Appendix H: RFLMA Contact Records

Summary of RFLMA Contact Records

ROCKY FLATS SITE REGULATORY CONTACT RECORD

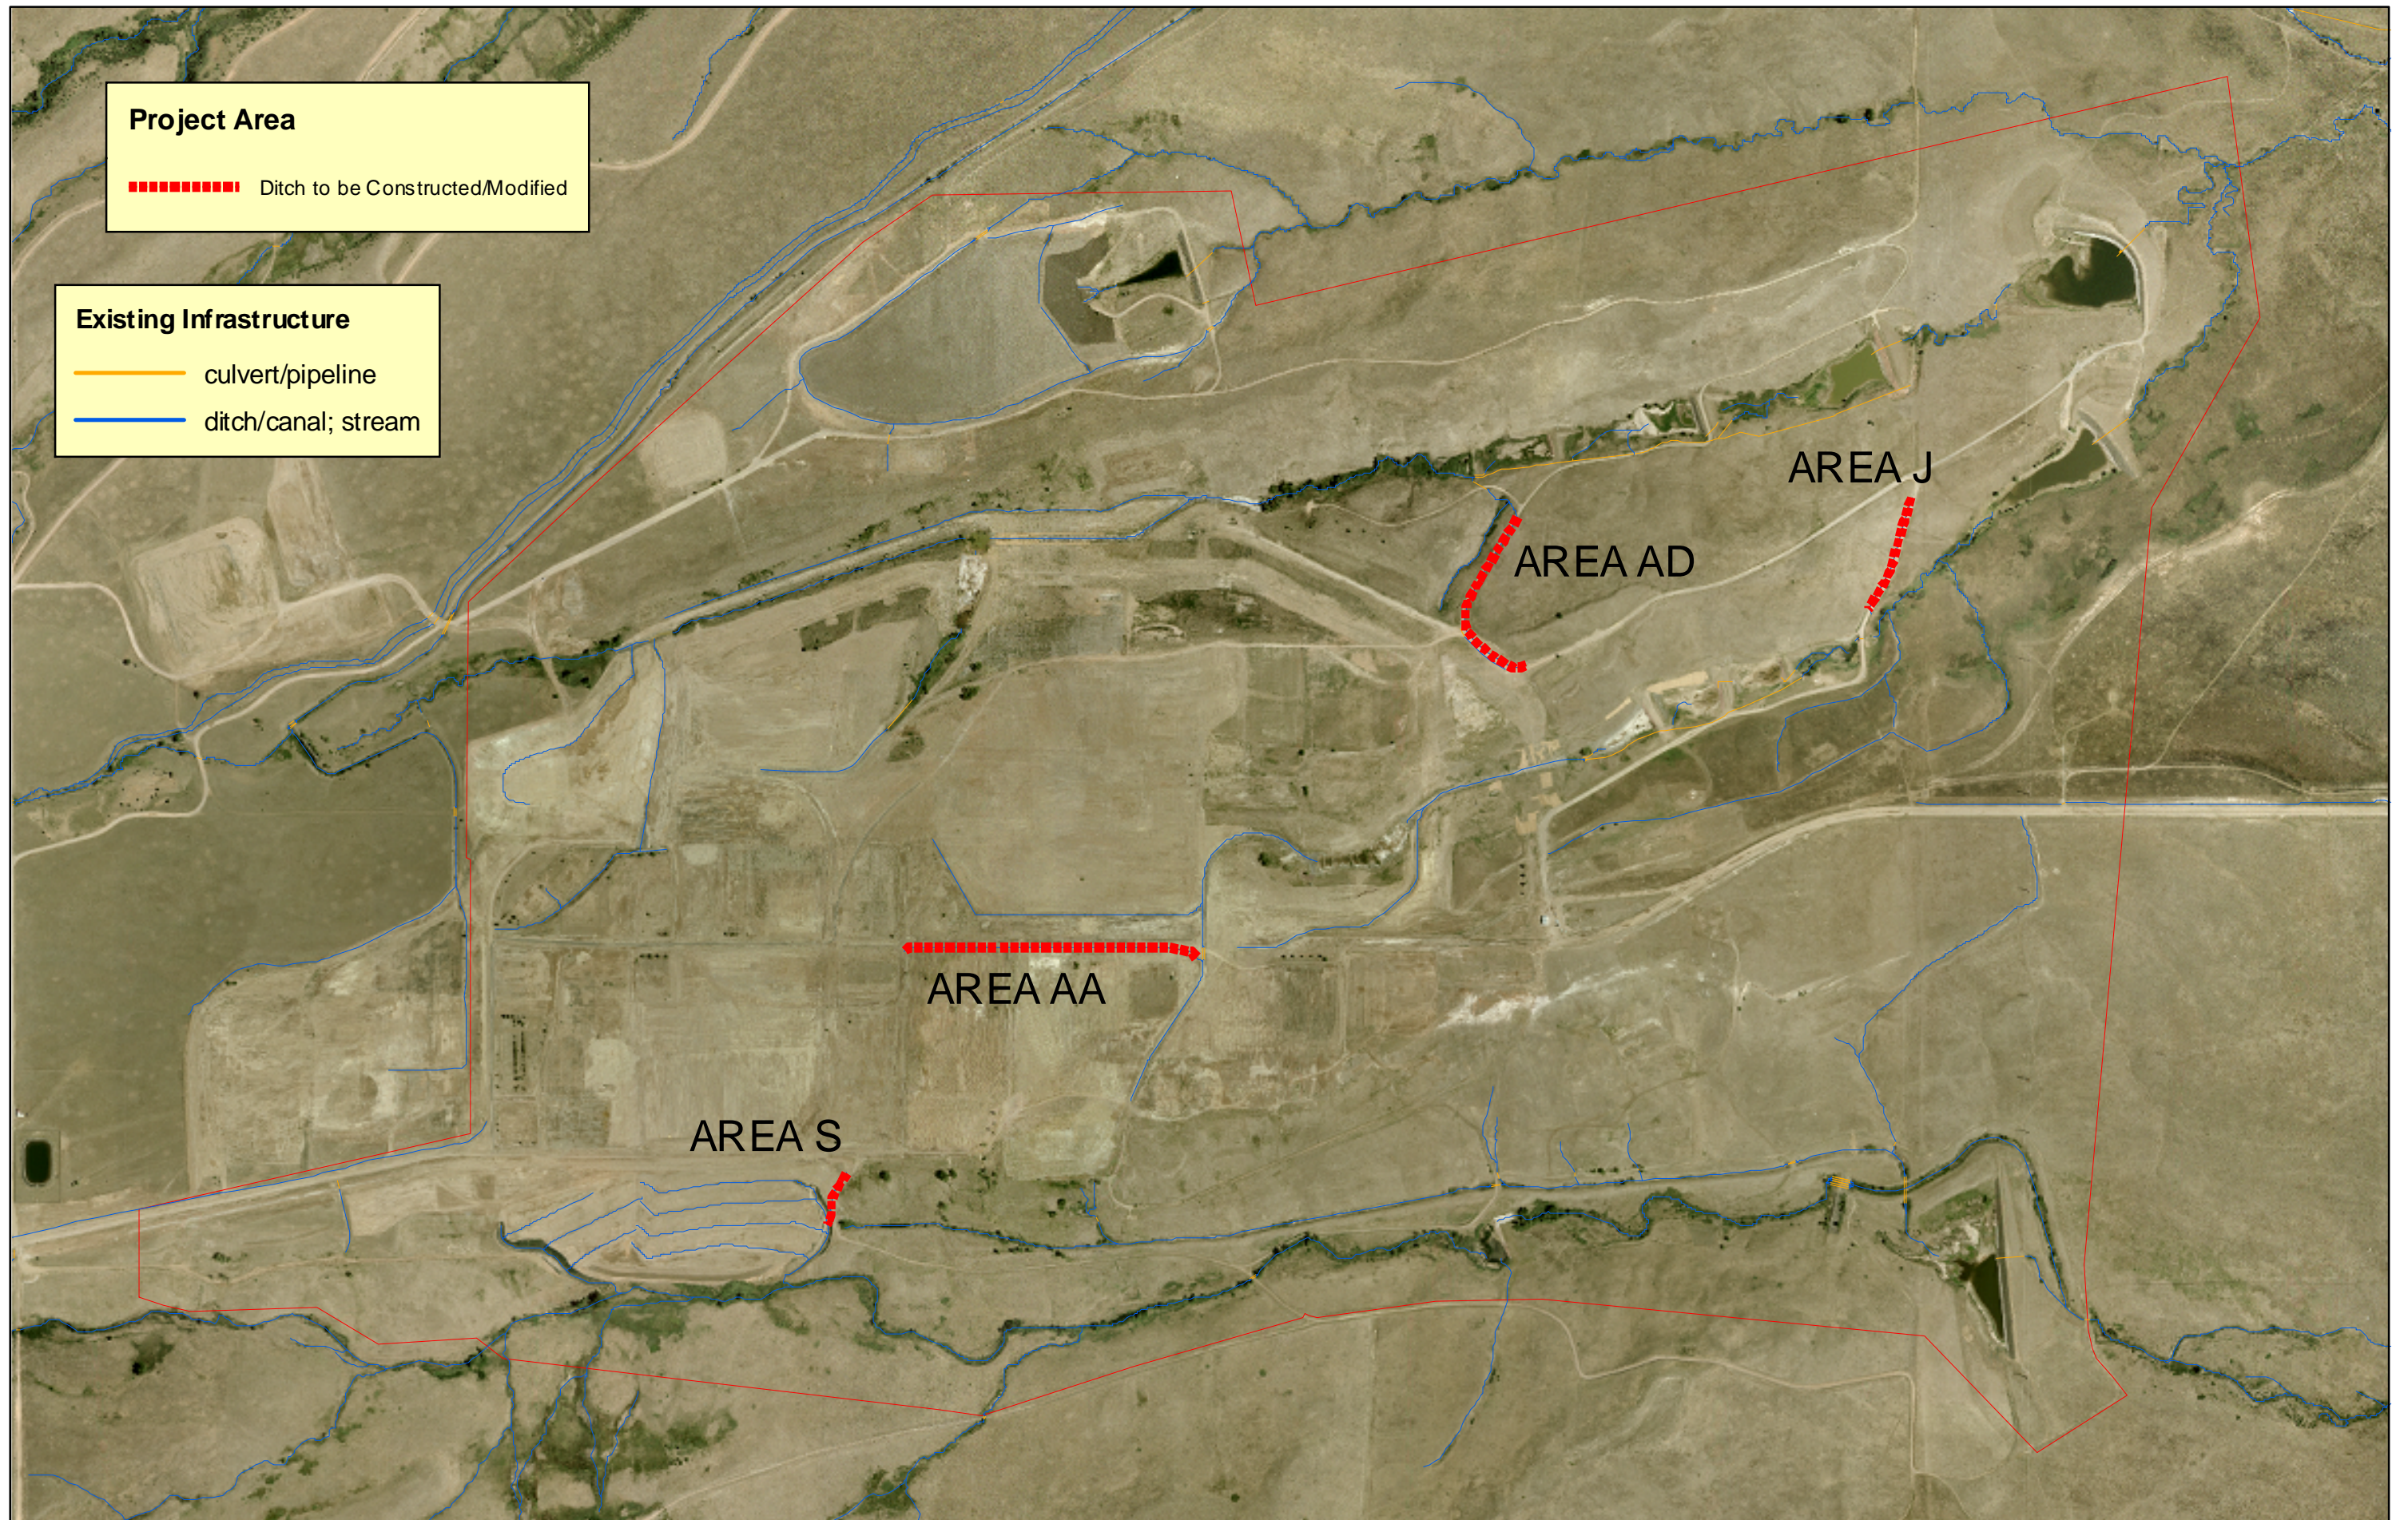
When completed, the center of the ditches will be 1 foot below the existing grade with a 3:1 taper up to the existing grade. The water bar depressions are 9 inches below the existing grade, and the hump is 9 inches above the existing grade.

Carl Spreng, CDPHE, approved the placement of the ditches and water bars as described in this contact record.

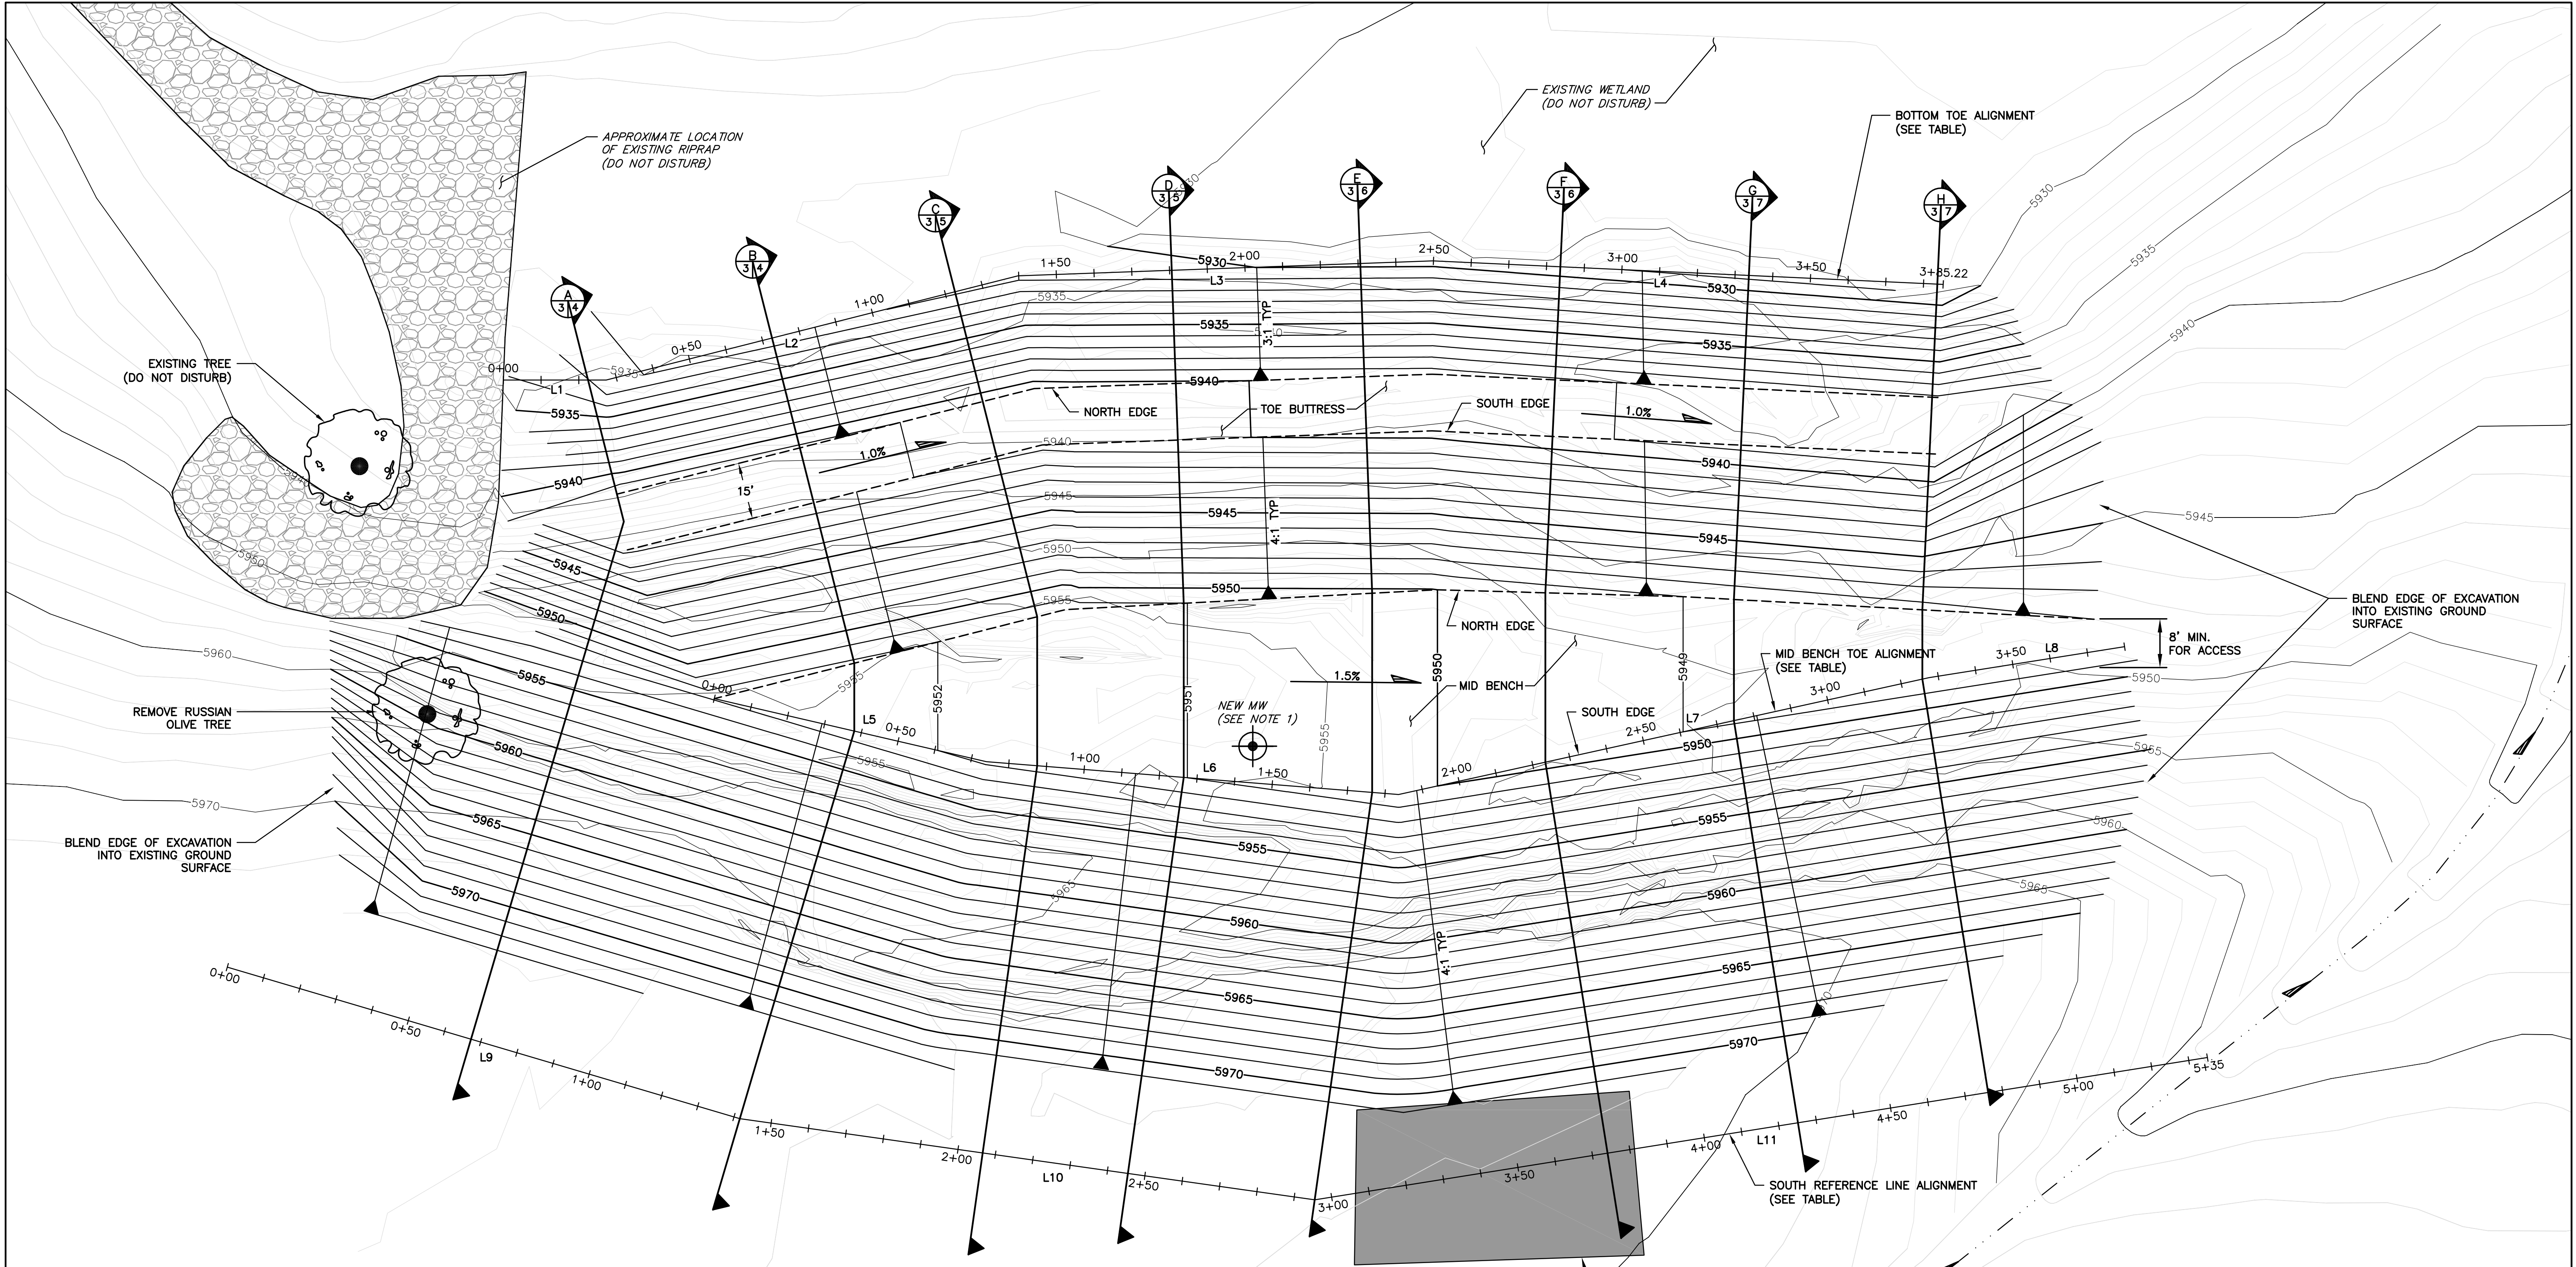
- IHSS 154 (PAC 900-154), Pallet Burn Site – Oil-contaminated pallets and other wood debris were burned in this area, which is located south of the slumping soils, just north of FC-5. The conceptual design drawing (Sheet 3) shows that the extent of regrading just touches the northern extent of IHSS 154, approximately between the southern end of Sections E and F (Sheets 6 and 7). Burning activities were conducted in 1965 and the area was removed sometime in the 1970s. Characterization of this IHSS in 2002, as part of IHSS Group 900-2, resulted in three of six sample locations with detectable levels of arsenic, and two of the three locations had arsenic above the wildlife refuge worker (WRW) soil action level specified in the Rocky Flats Cleanup Agreement (RFCA), both at depths greater than 4.5 feet below the surface.

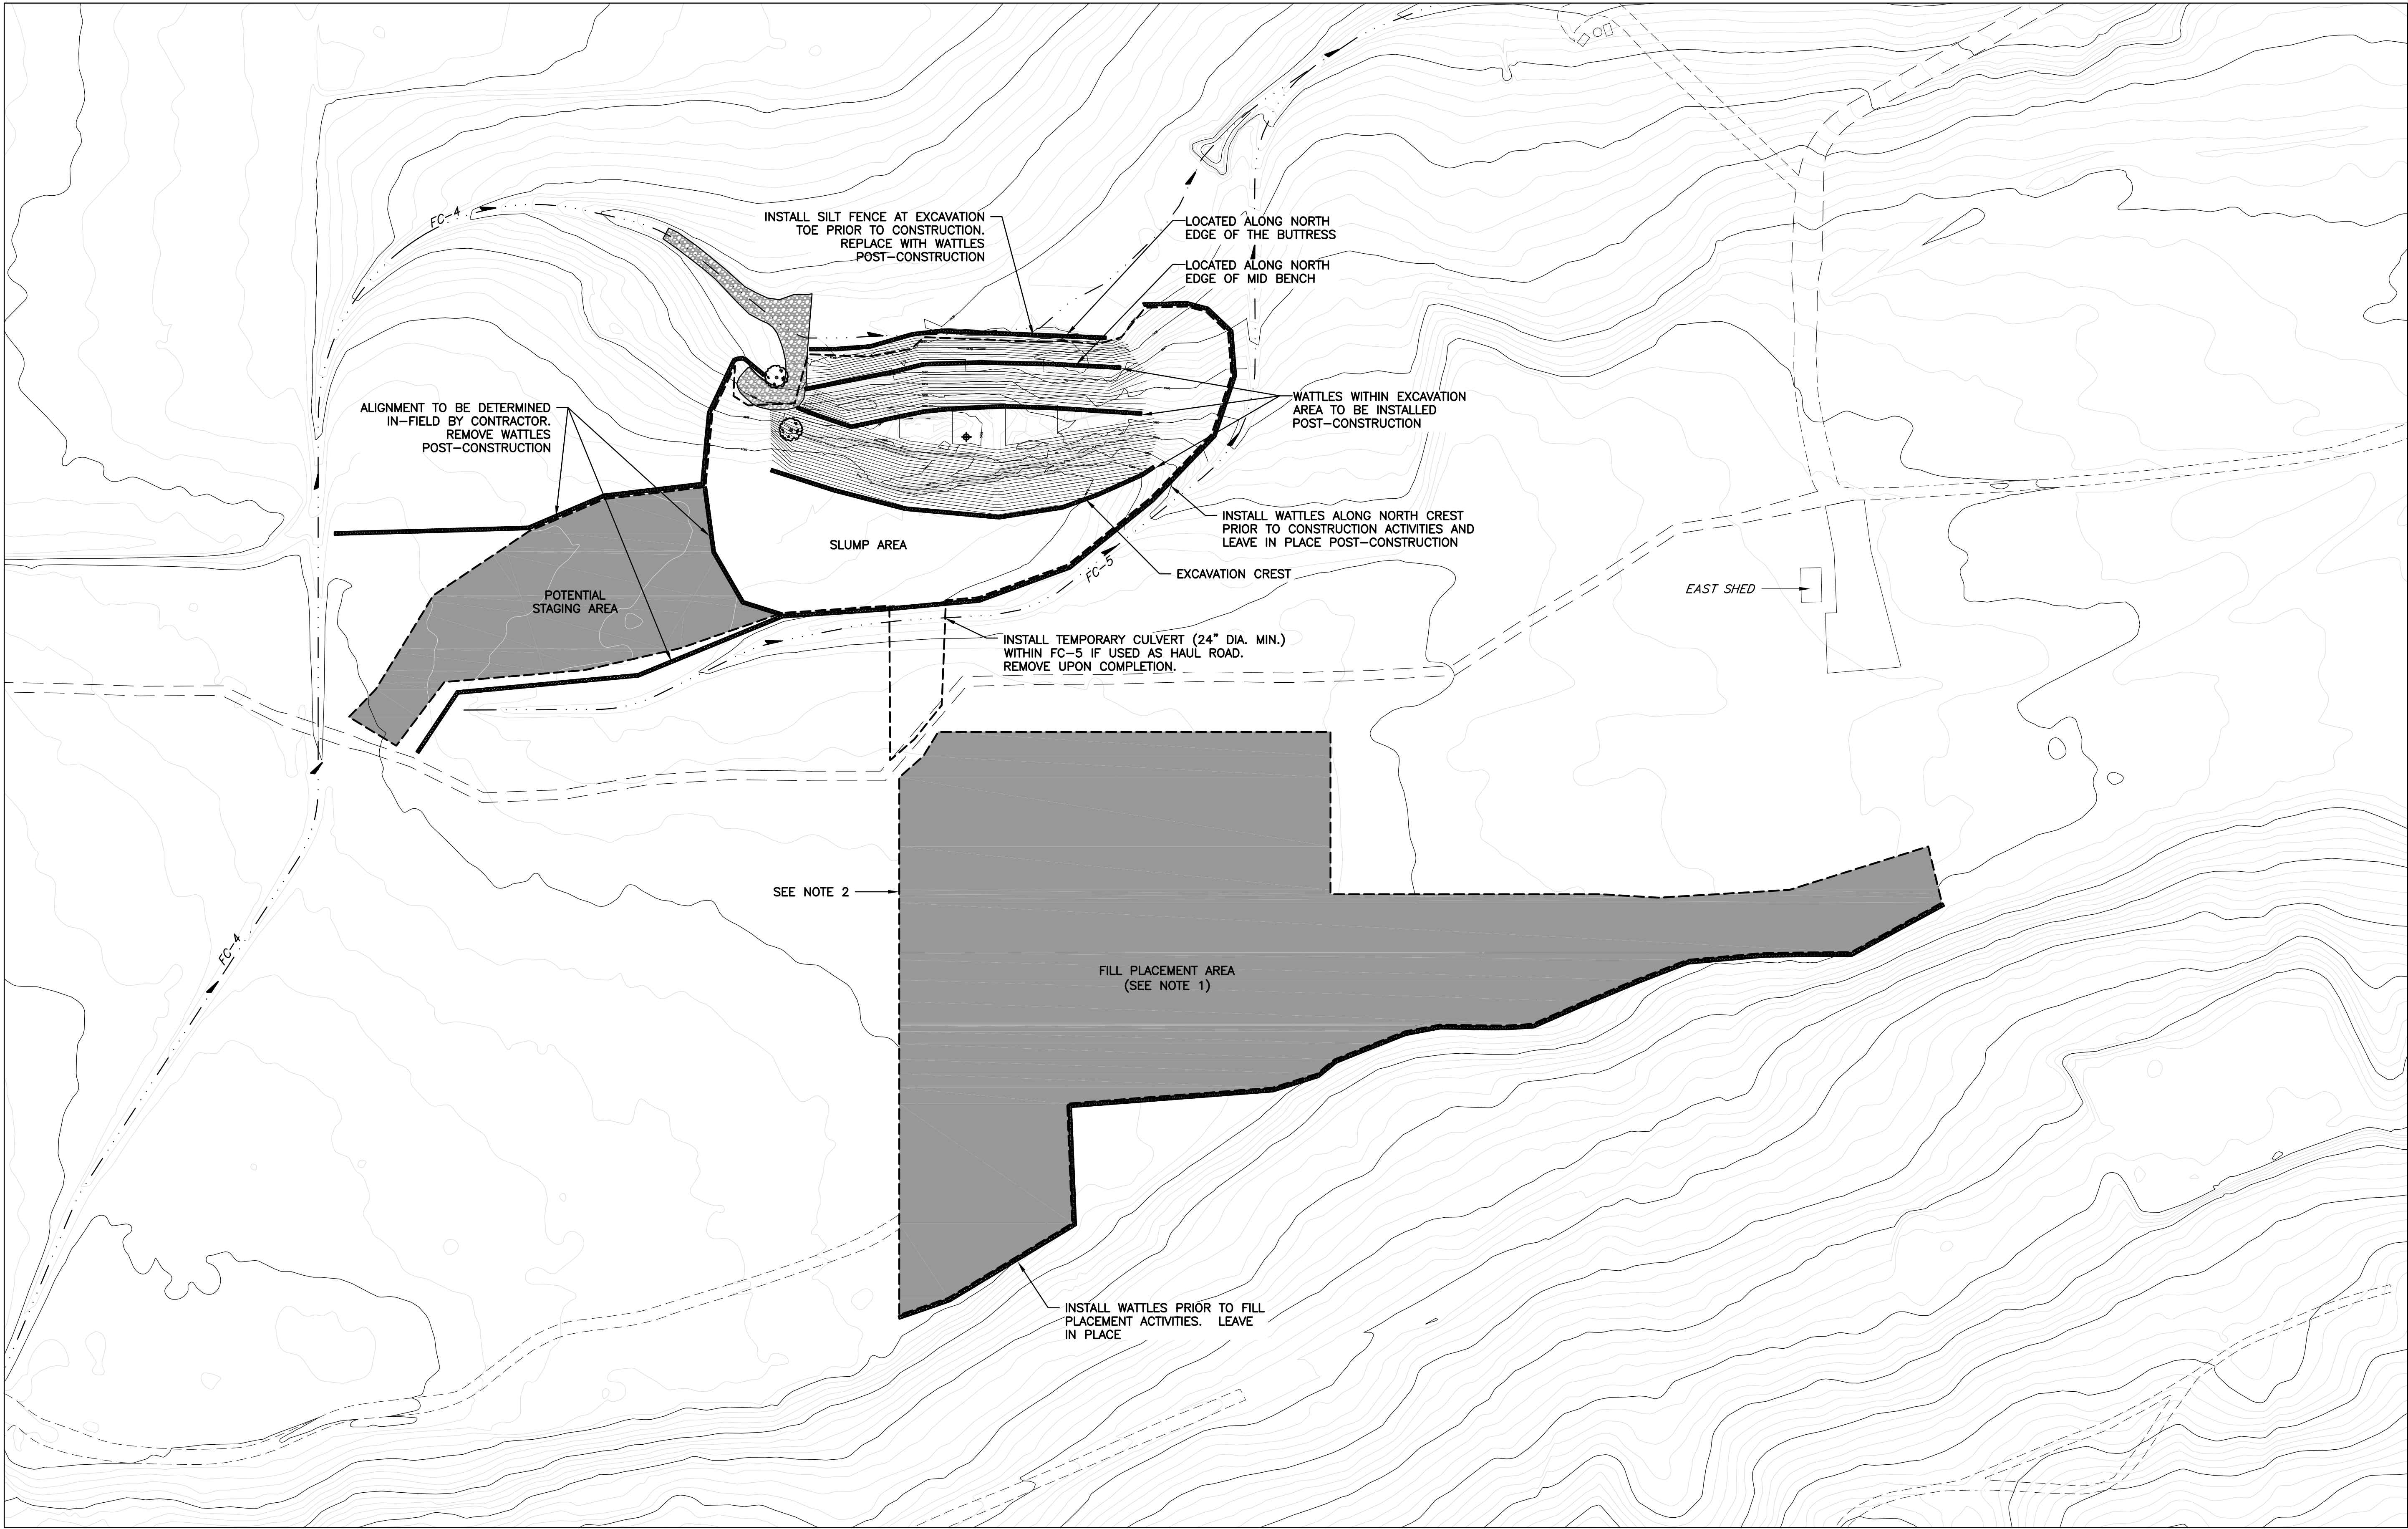
The regrading is projected to generate approximately 7,000 cubic yards of excess material. This soil will be spread at and adjacent to the former 903 Pad area (refer to Design Sheet 8), which will facilitate revegetation efforts in this area. The fill placement activity will conform with the applicable institutional controls, and the final elevation after fill placement and reseeded is expected to be slightly above the existing elevation. Erosion controls for the regrading excavation and fill activities will be employed in accordance with the Central Operable Unit (OU) Erosion Control Plan.
